RIVERPARK COMPASS UPDATE

Bulletin Type:	INC	Publication Date:	June 2021
Bulletin #(s):	21-022	Make(s):	Entegra
Job Code(s):	N/A	Model(s):	Cornerstone & Anthem & Aspire & Reatta & Reatta XL & Embark
Flat Rate(s):	N/A	Model Year(s):	2022

Incident:	WRONG COMPASS HEADING OVER THE RVC NETWORK
Affected Units:	- 2022 Entegra Cornerstone - 2022 Entegra Anthem - 2022 Entegra Aspire - 2022 Entegra Reatta - 2022 Entegra Reatta XL - 2022 Entegra Embark
Parts List:	- N/A
Misc. Tools & Supplies:	- N/A
Parts Return Information:	- N/A

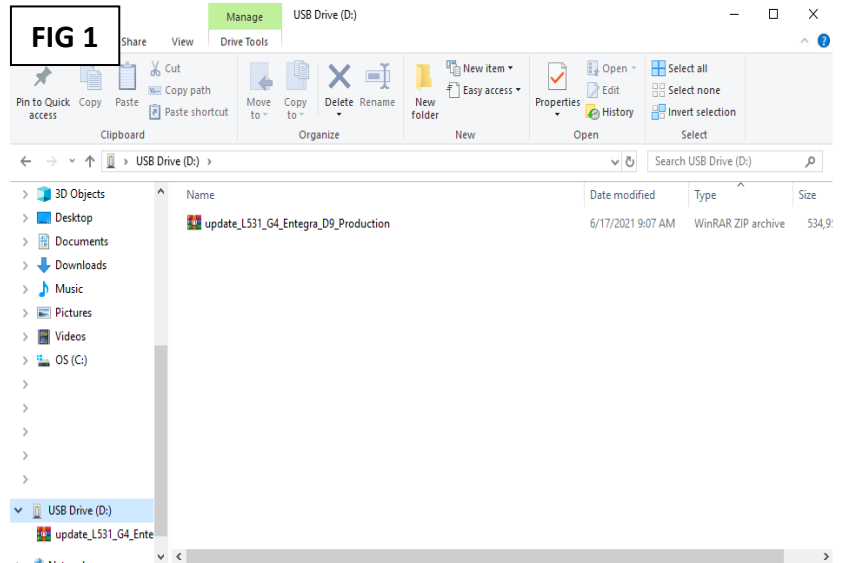
1. Select the link below corresponding with the system affected. Once the firmware is downloaded to the computer, copy the zip file to a blank USB stick. Below in fig 1 is what you should see on the USB when done properly.
2. D9 Firmware – Dual 9” monitor system
 - a. http://service.xitesolutions.com/Content/Firmware/Entegra/2022/ClassA/update_L531_G4_Entegra_D9_Production.zip
3. S9 Firmware – Single 9” monitor system
 - a. http://service.xitesolutions.com/Content/Firmware/Entegra/2022/Reatta/update_L602_4_Entegra_S9_Production.zip
